Informal document GRSP-52-21
(52nd GRSP, 11 – 14 December
2012, agenda item 14)

ECE-R29/02 manikin
update

ECE/TRANS/WP.29/GRSP/2012/24

Manikin for regulation ECE-R29/02

ECE-R29/02 manikin joints

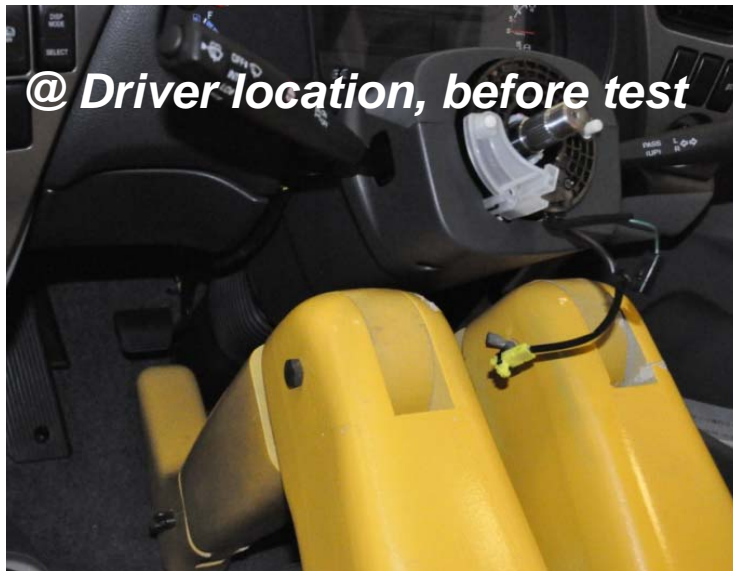
- The upper legs are not articulated
 - one with the other
 - with his torso
- The head is not articulated with the torso
- Only feet, lower legs & arms are articulated with pivots

Modifications proposed to ECE-R29/02 manikin

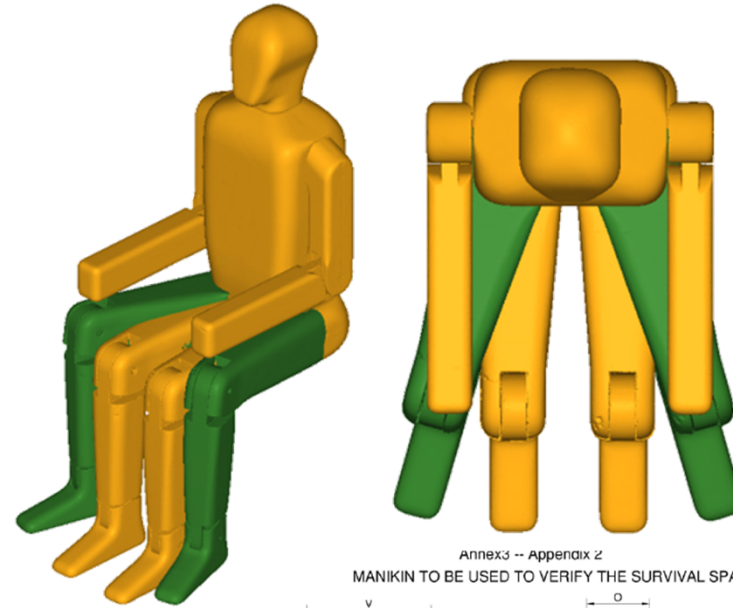
Without changing manikin's dimensions (fixed by ECE-R29/02 regulation), **it is possible to**

1. **add hip joints** to enable upper legs rotation about the vertical axis [20°]

Annex 3 -- Appendix 2
MANIKIN TO BE USED TO VERIFY THE SURVIVAL SPACE

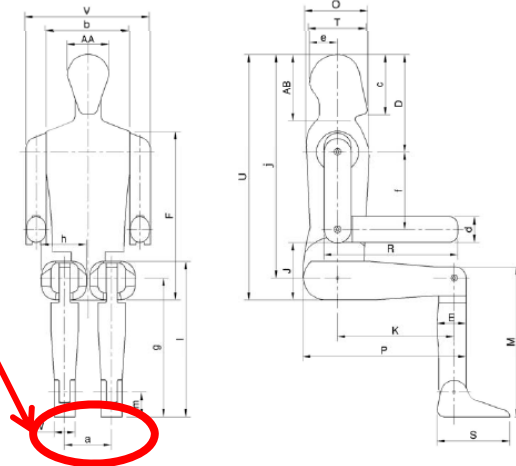
Same definition as ECE-R29/03

Distance a (distance between hip point centers) is still valid

Modifications proposed to ECE-R29/02 manikin

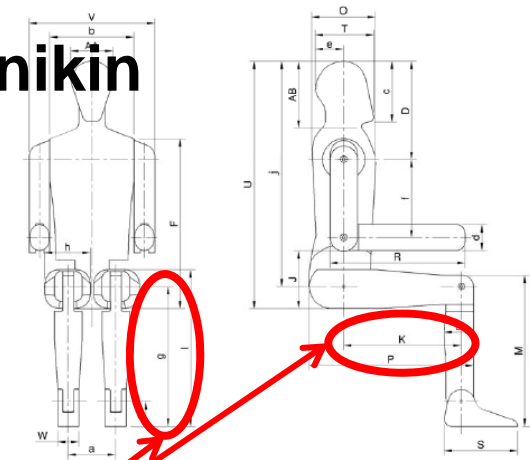
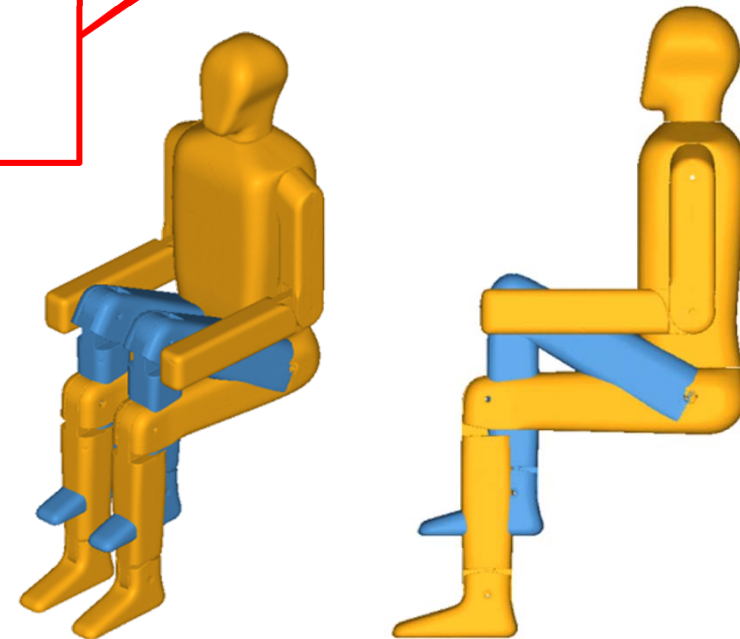
Without changing manikin's dimensions (fixed by ECE-R29/02 regulation), ***it is possible to***

Distance K and g (distance between hip pivot and knee pivot and knee pivot height from ground) is still valid

1. **add joints between upper legs to enable rotation about the vertical axis**
2. **add joints between upper legs and torso to enable rotation about the transverse axis**
